Determination 2019/039

Regarding the exposure zone for building work located near a tidal estuary at 45 John Burke Drive, Aotea, Porirua

Figure 1: Aerial photograph⁶ showing the building site (arrow)

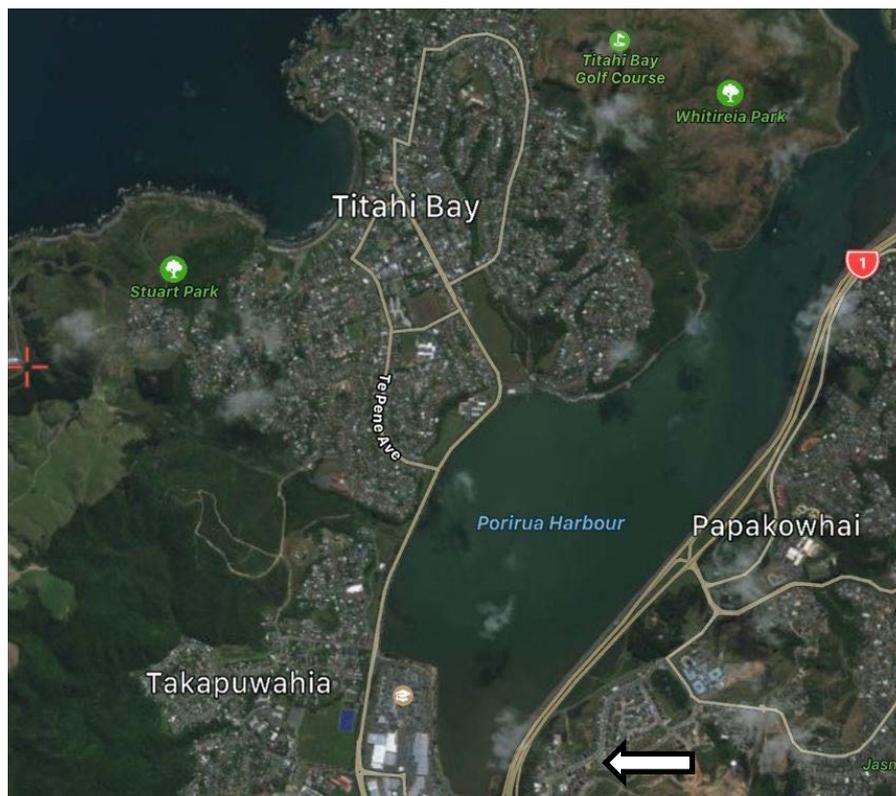
- 2.1 The building work considered in this determination is a new single storey house situated in Aotea Sub Division, Porirua. The site is approximately 375m away from the closest point of the Porirua tidal estuary. The site is in a very high wind zone with the prevailing wind running south-west to north-east. The nearest surf beach is Titahi Bay, which is about 2.7km north-west of the site. Figure 1 (taken from the expert’s report) shows the building site, the tidal estuary (Porirua Harbour) and the surf beach (Titahi Bay).
